Access Compliance Report

Public Rights-of-Way

(Curb Ramps)

Intersection ID: 31500	Main Street: CARLEEN_WAY_DR	Cross Street: GRIER_SPRINGS_LN	Location: W
ADA ID: D303379F3C19	Ramp Type: PerpDiag	Initial Pass/Fail: Fail	Overall Compliance: No
Severity Score: 10			
Codes/Mitigation Info/Possible Solution		Field Measurements/Component Compliance

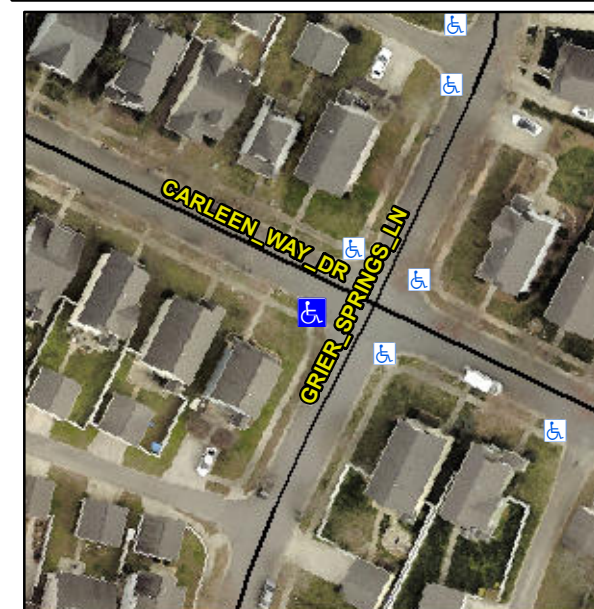
Not Found, R304.5.1, R304.5.3

Compliance	Description	Data	Compliance	Description	Data
N/A	Ramp Length (in)	63.0	Yes	Ramp Slope (%)	6.2
No	Ramp Width (in)	43.0	No	Ramp XSlope (%)	2.4
N/A	Flare Type LT	N/A	N/A	Flare Type RT	N/A
N/A	Flare Slope LT (%)	N/A	N/A	Flare Slope RT (%)	N/A
N/A	Flare Traversable LT?	N/A	N/A	Flare Traversable RT?	N/A
N/A	Landing Length (in)	N/A	N/A	DWS Provided?	N/A
N/A	Landing Width (in)	N/A	N/A	DWS Contrast?	N/A
N/A	Landing Slope (%)	N/A	N/A	DWS Length (in)	N/A
N/A	Landing X Slope (%)	N/A	N/A	DWS Full Width?	N/A
N/A	Landing Curb? (Y/N)	N/A	N/A	DWS Offset (in)	N/A
N/A	Shared Landing?	N/A			
N/A	Gutter Ponding?	N/A	N/A	Gutter Slope (%)	N/A
N/A	Gutter Lip Ht (in)	N/A	N/A	Gutter X Slope (%)	N/A
N/A	Painted X Walk1?	No	N/A	Painted X Walk2?	No
	X Walk 1 Direction	To SE		X Walk 2 Direction	To NE
N/A	X Walk 1 Width (in)	N/A	N/A	X Walk 2 Width (in)	N/A
	X Walk 1 Slope (%)	4.0		X Walk 2 Slope (%)	8.2
	X Walk 1 X Slope (%)	4.0		X Walk 2 X Slope (%)	3.6

N/A	Ramp inside XWalk1?	N/A	N/A	Ramp inside XWalk2?	N/A
	Road Slope (%)	0.9	N/A	Clear Space?	N/A
	Road X Slope (%)	5.8	N/A	Clear Space to XWalk (in)	N/A
N/A	Any Obstructions?	N/A	N/A	Storm Grate/Utility Hazard?	N/A
	Obstruction Type			Storm Grate/Utility Type	
		N/A			N/A
			Yes	Surface Condition? (G/P)	Good

Remove & Replace Curb Ramp With Two New Directional Ramps or Equivalent.
